RE: COMPLIANCE SUBMISSION (NO. 3) IN RELATION TO LIDL DISCOUNT FOODSTORE ANCHORED DEVELOPMENT AT MAIN STREET UPPER, NEWCASTLE, CO. DUBLIN

SOUTH DUBLIN COUNTY COUNCIL PLANNING REGISTER REFERENCE: SD22A/0312

2.0 RESPONSE RE. BUILDINGS C+D WINDOWS TO HISTORIC FAÇADES

Project	Proposed Lidl Store at Newcastle, Co. Dublin
Title	Building D - Proposed Elevations & Section
Client	Lidl Ireland GmbH
Dwg. No.	PA-303
Job No.	22013

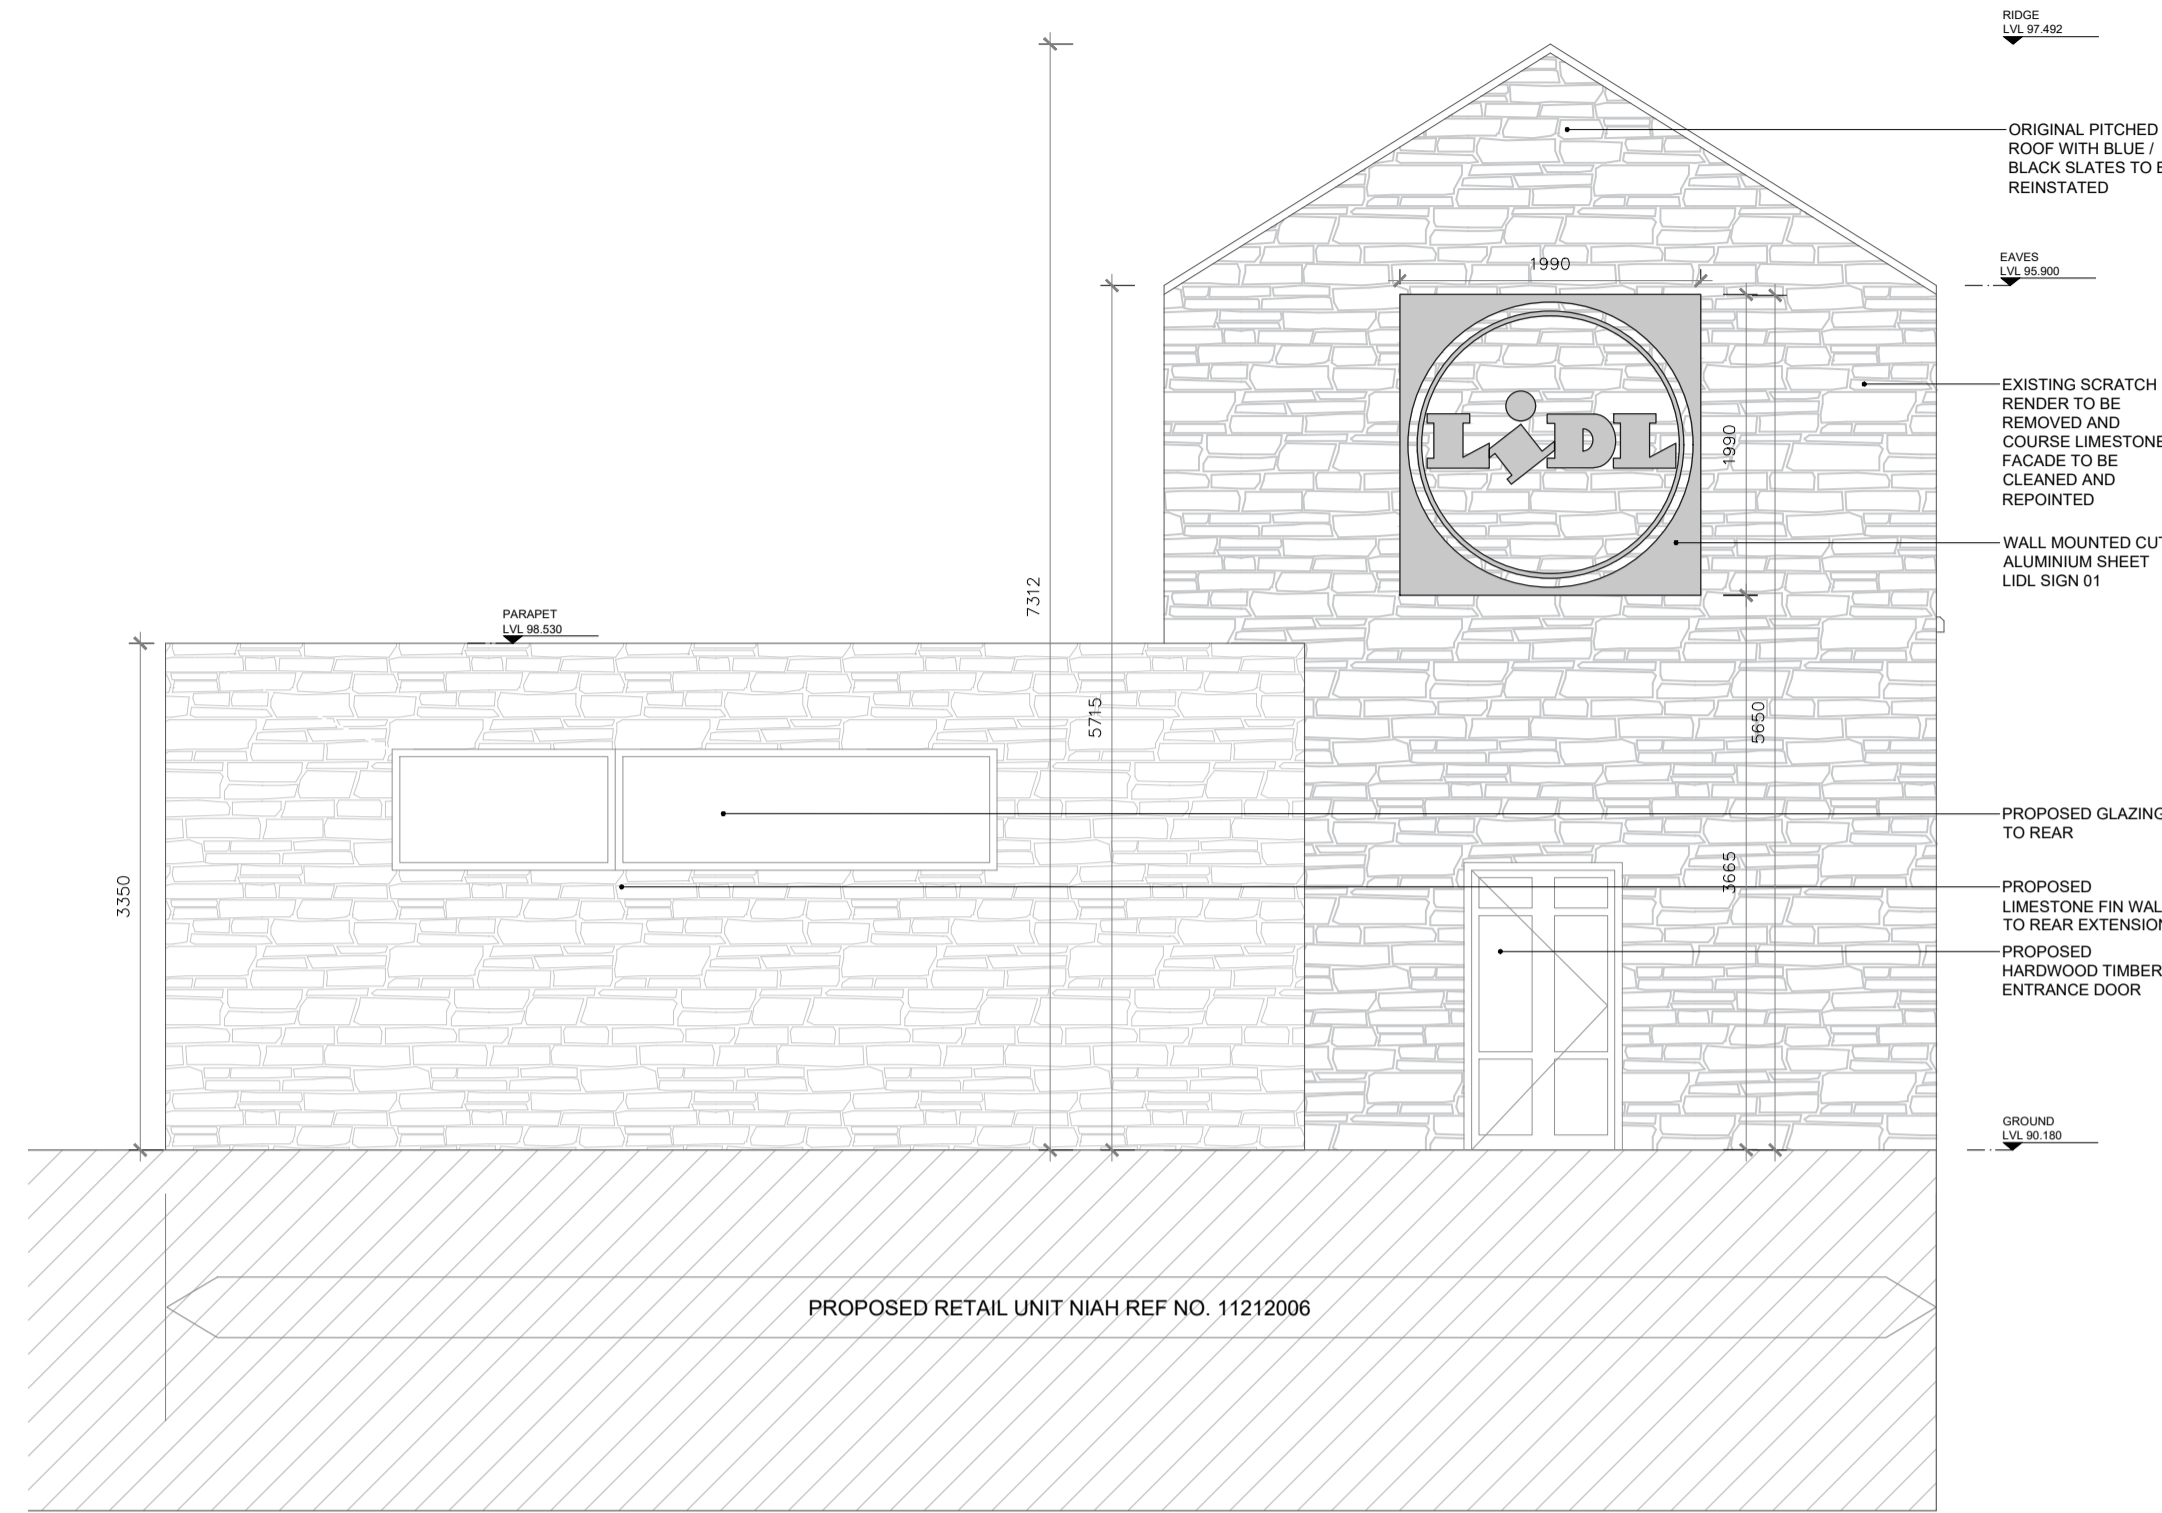
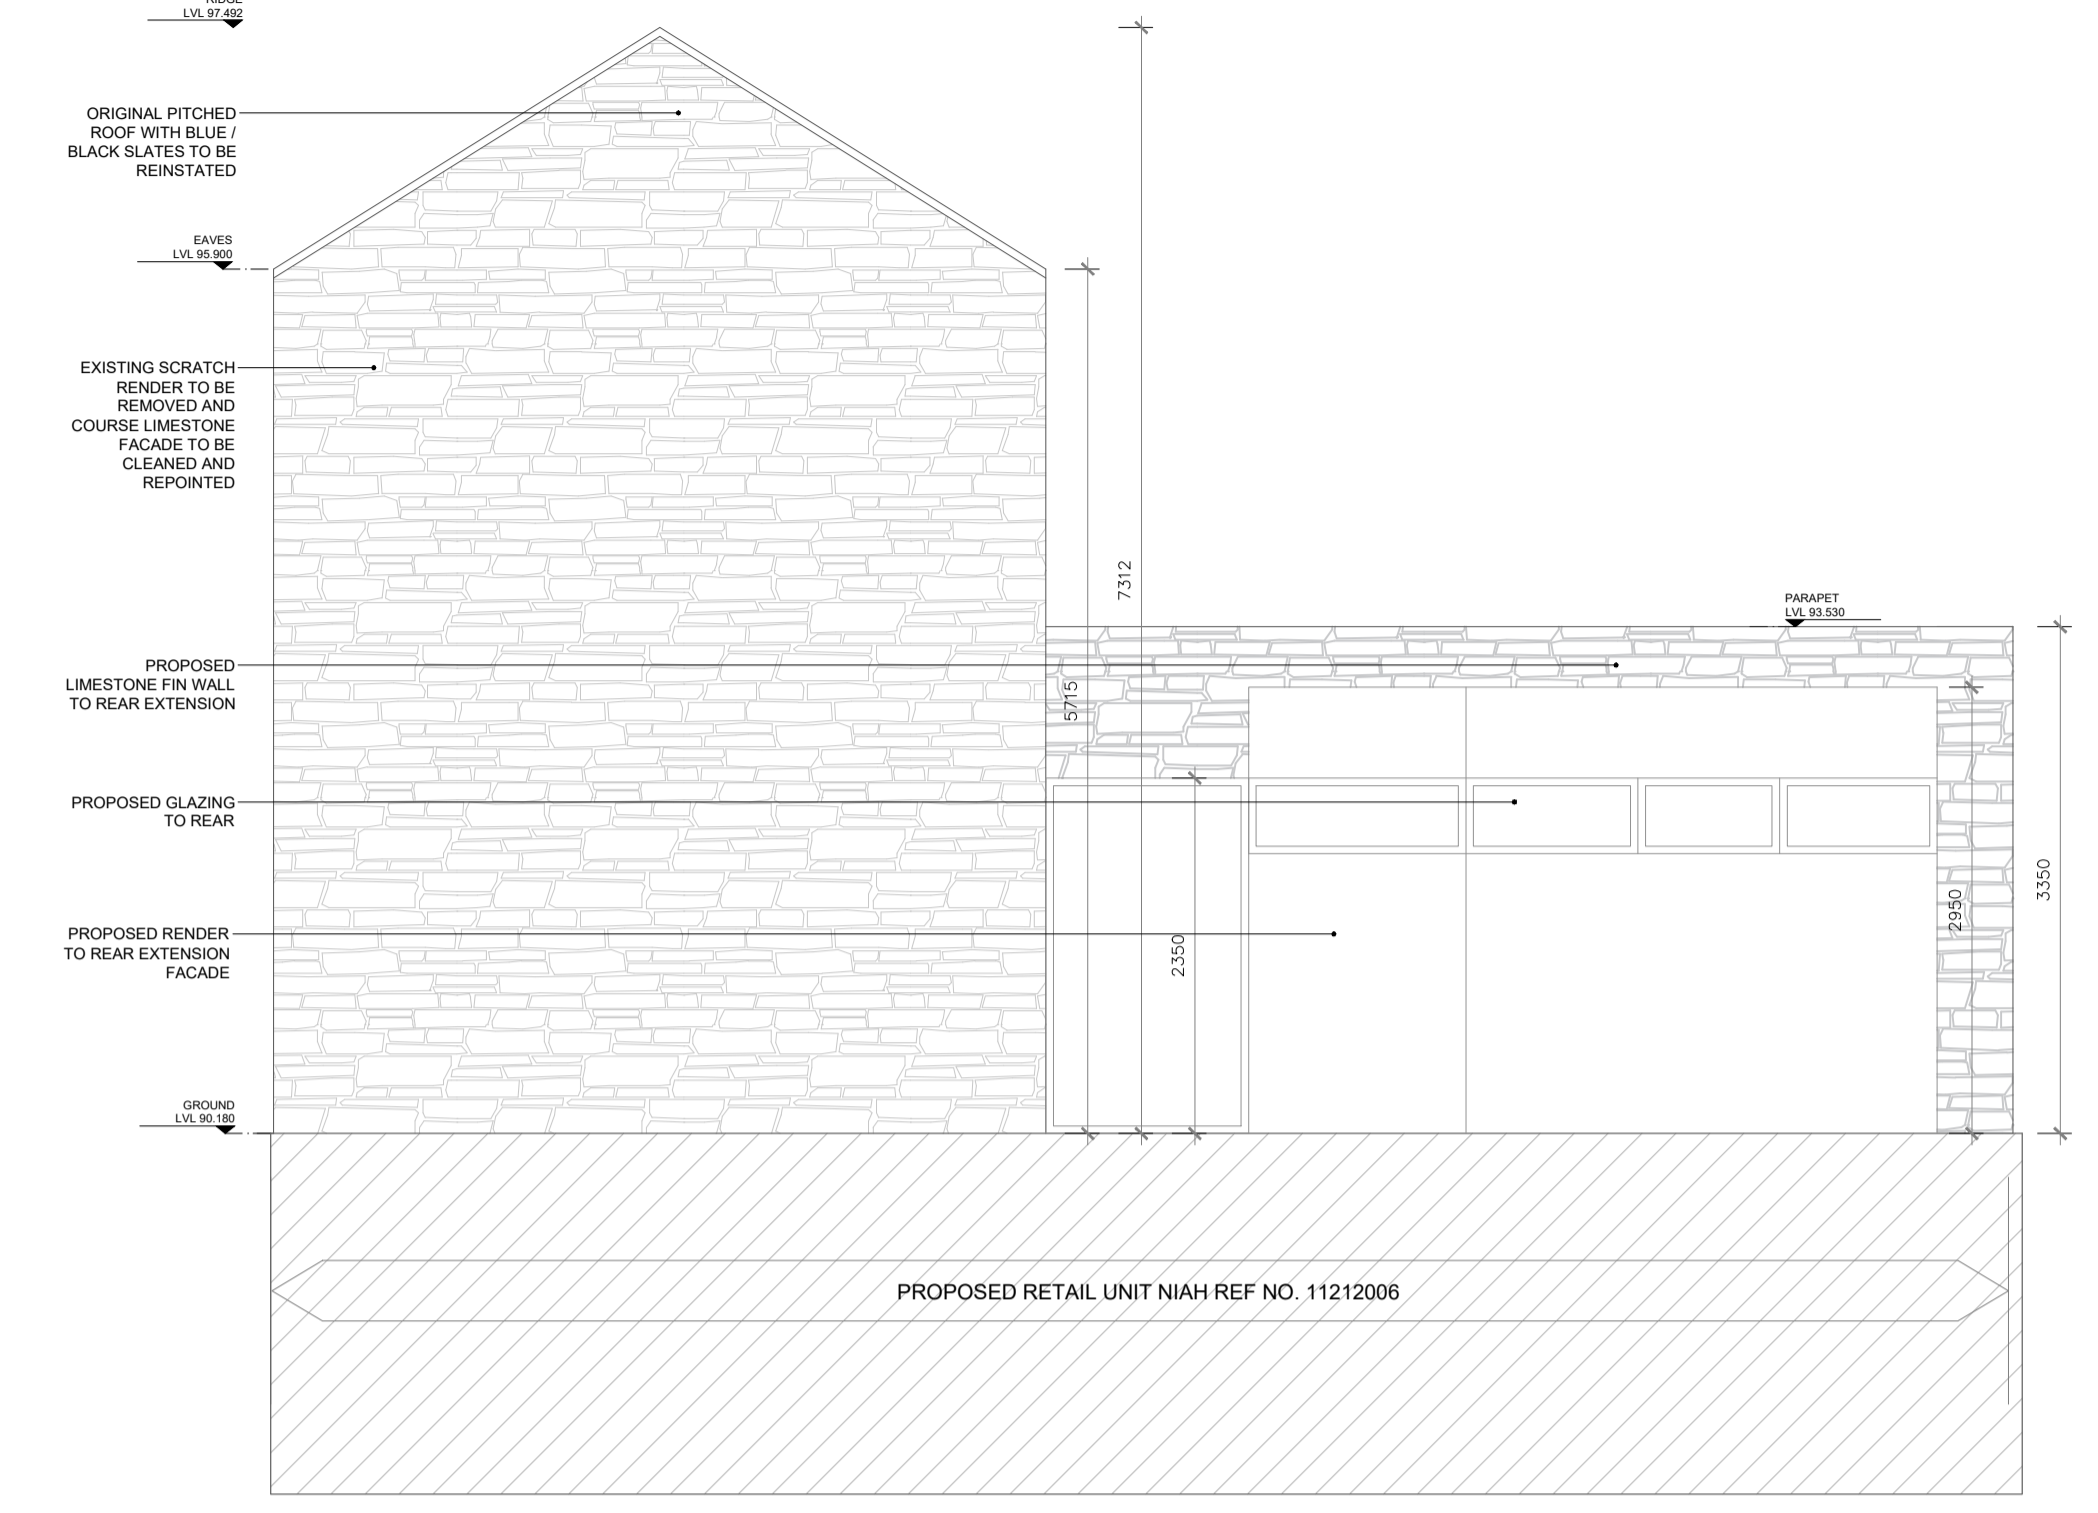
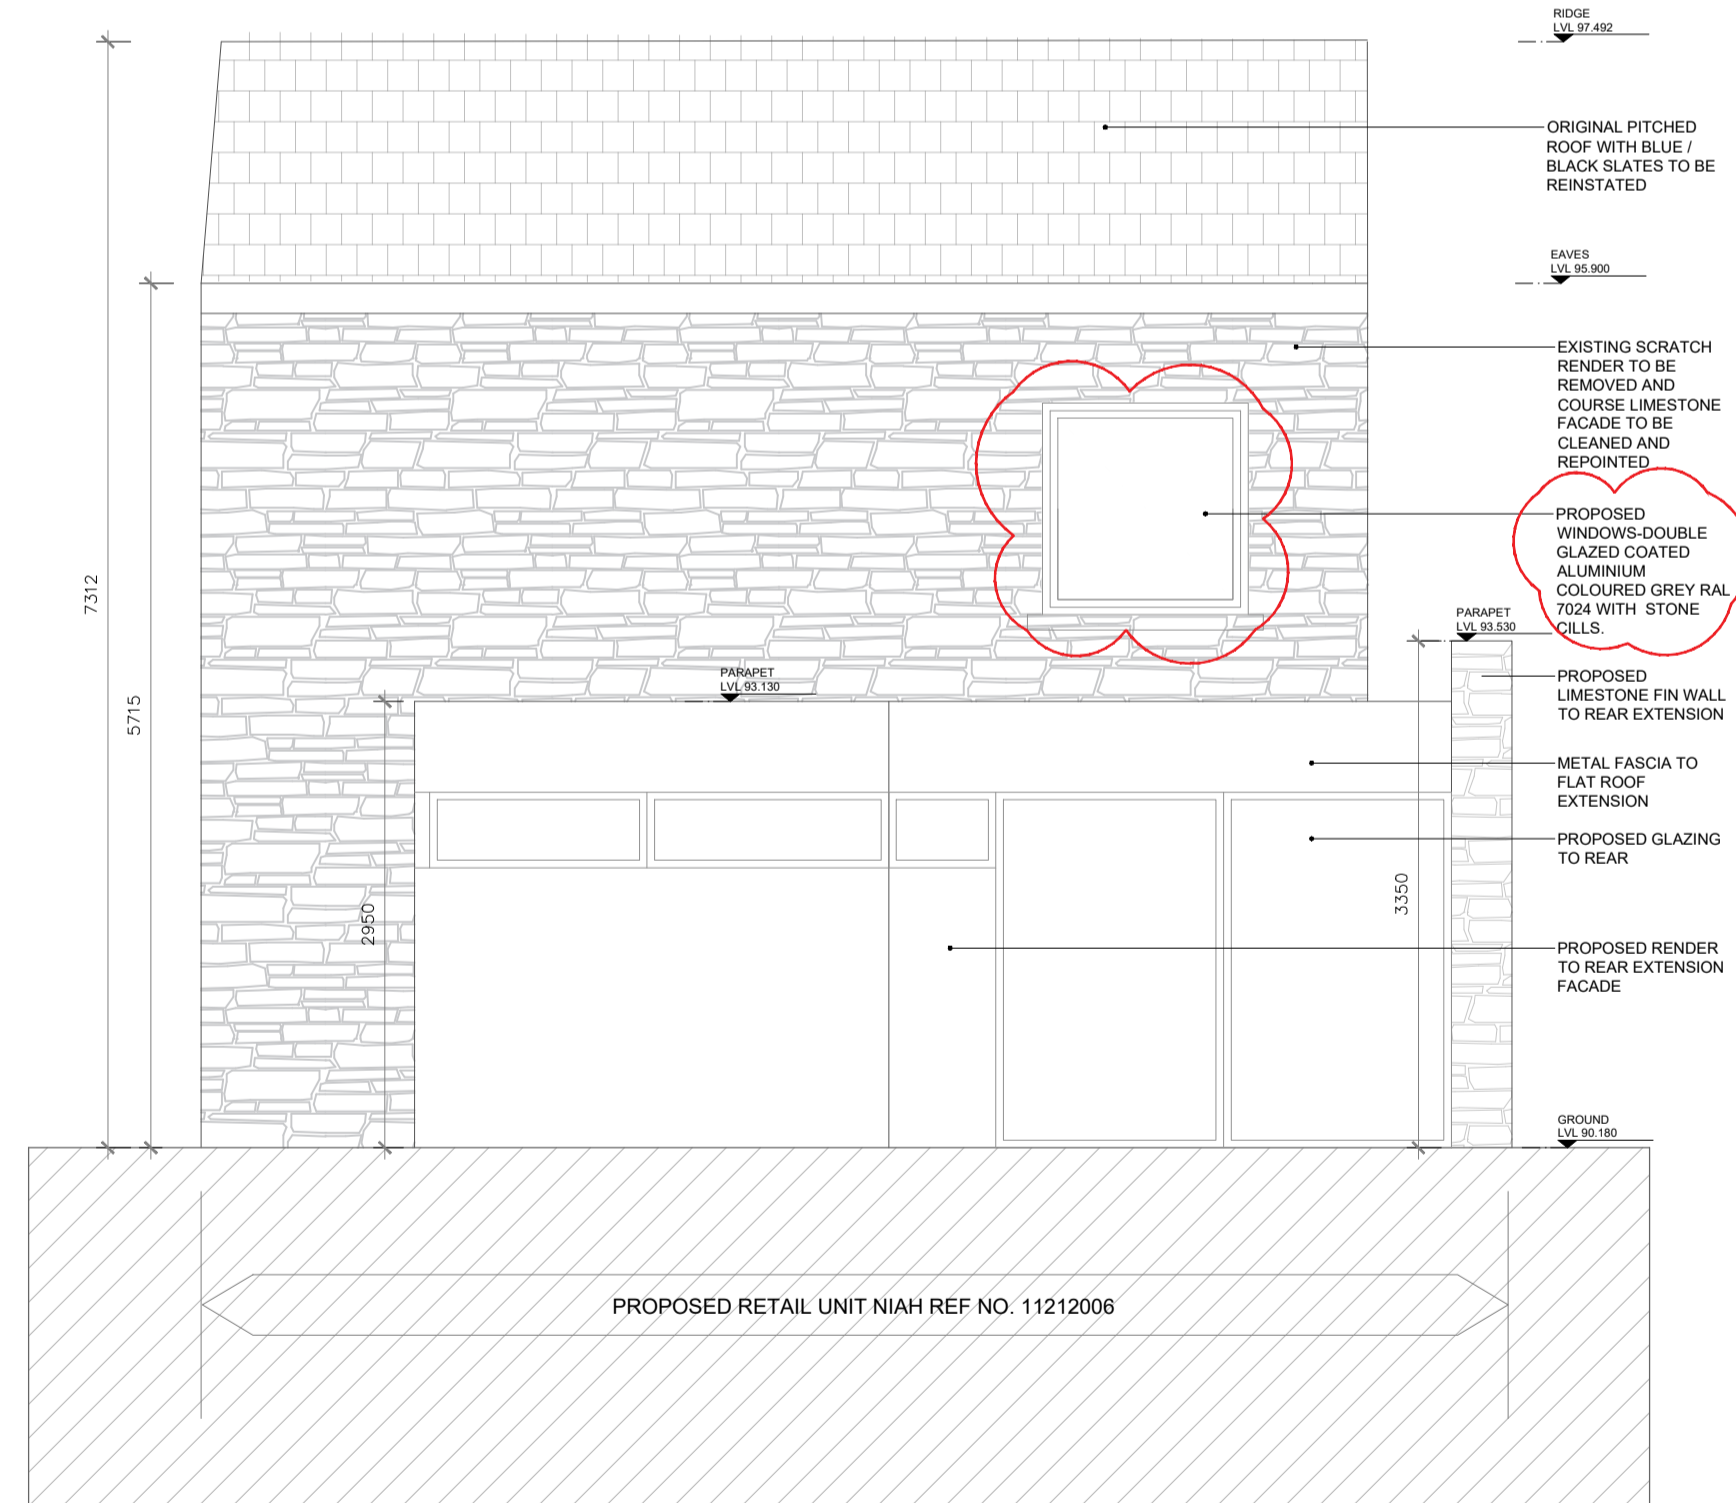
There was just one item that I would like to seek further clarification on and that is the new sash windows proposed to the historic building façade. It is important that if historic window types are to be reinstated that this is done with windows that will match the original profile and material type to ensure they are historically correct and so that you don't end up with a thick unit and window that looks small and reduces natural light. The finish colour should match in with the colour palette and therefore the sashes should be painted in a dark colour rather than white as shown. I would argue however that if there is no evidence of the window type at this location that modern windows could be considered to tie in with the overall design of the Café/retail unit and Buildings C+D). I would therefore advise that this item is addressed or clarified.

We enclose drawings and details (see Appendices B, C & E) illustrating the proposed window finishes and specification.

Rev.	Description	Date	Initials
A	Metal Lid Sign added	02/02/23	MP
B	Windows type uploaded	12/03/24	EL
